Docket Item # 4
BAR CASE #2010-0324

BAR Meeting
December 1, 2010

ISSUE: Alterations (HVAC Screening)

LOCATION: 120 South Fairfax Street

Figure 6. Proposed fence design.

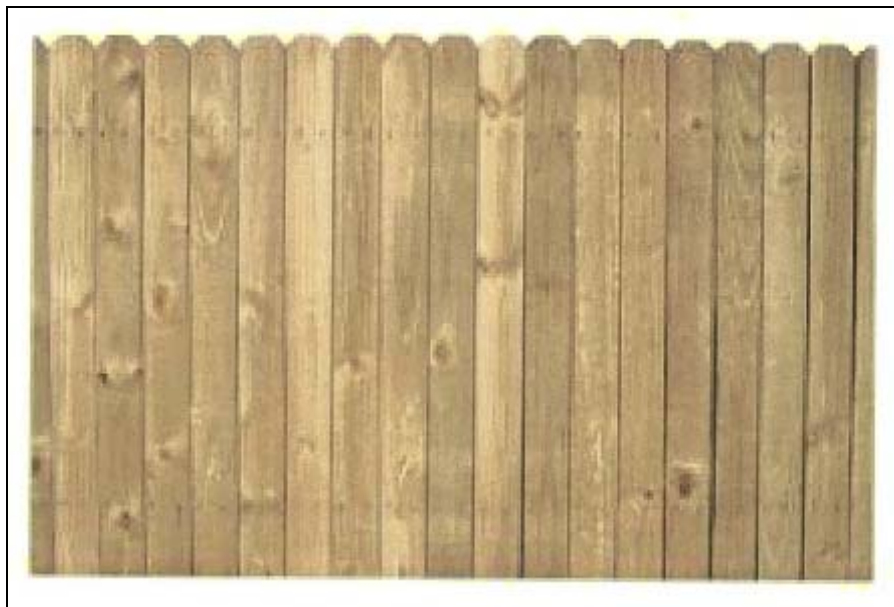
STAFF RECOMMENDATION: Staff recommends approval of the application with the conditions that the fence be painted a dark green or dark red color and that corner posts with decorative post caps be added to the fence design.

In this case, the HVAC condenser units and associated screening are located in the least obtrusive location possible on this property. When the applicant originally approached Staff, the proposal was to install three of the five units along the southern elevation of the building adjacent to the alley. In this proposal, the units would have been highly visible from South Fairfax Street through the existing iron fence with brick piers and the units would have visually destroyed what is currently a charming urban garden area. Staff worked with the applicant to find a more appropriate location on the rear of the property. While it is never ideal to install five HVAC condenser units in one location, Staff recognizes the needs of modern HVAC equipment for a building of this size and notes that it will allow the existing window units to be removed. Further, the proposed location of the units and screening is adjacent to a parking area and minimally visible from South Fairfax and South Lee streets. Staff recommends that the fence design be further refined through the addition of corner posts with decorative post caps and that the fence be painted a dark red or green color to recede.
